SOUTHERN NEVADA AMENDMENTS

2012 INTERNATIONAL RESIDENTIAL CODE

PREFACE

FIGURE R302.1
MINIMUM FIRE SEPARATION DISTANCE DETAIL

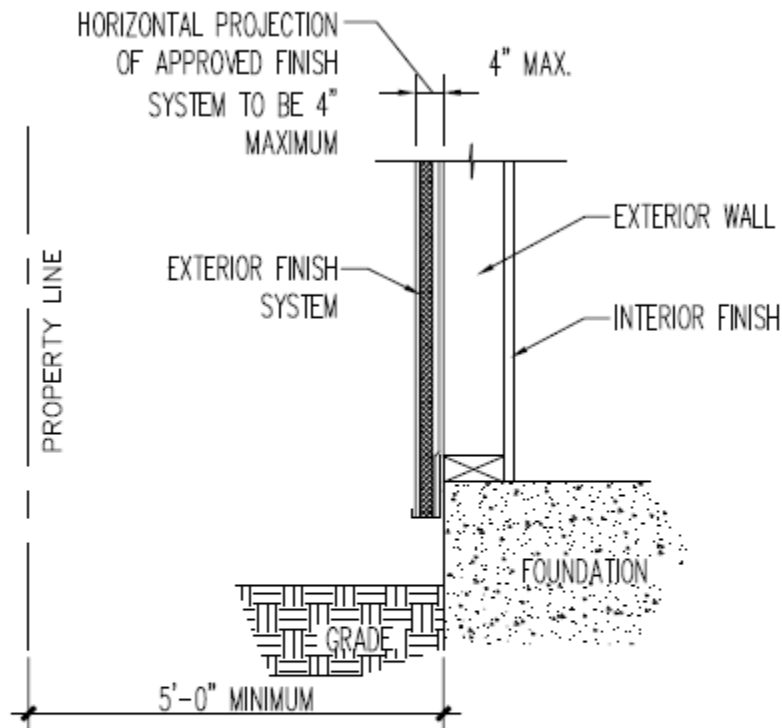
Revise Section R302.1, as follows:

R302.1 Exterior Walls. Construction, projections, openings and penetrations of *exterior walls* of dwellings and accessory buildings shall comply with Table R302.1 (1); or *dwellings* equipped throughout with an *automatic sprinkler system* installed in accordance with Section P2904 or IFC shall comply with Table R302.1(2). To determine when protection is required by Table R302.1(1), the minimum fire separation distance shall be determined from property line to the finish face of the wall except where the foundation distance from property line is 5 feet or greater, the foundation distance will be used for that wall only in accordance with Figure R302.1.

7. When there are no eave, attic or gable-end vent openings, the unprotected eave is limited to a maximum of 12 inches (305 mm) beyond the wall construction into the minimum fire separation distance. The unprotected eave projection is further limited to a maximum depth of 24 inches (610 mm) from the roof sheathing to the bottom of the projection.

NOTE: INTERIOR AND EXTERIOR WALL FINISH SHALL CONTINUE TO FULL HEIGHT OF WALL.
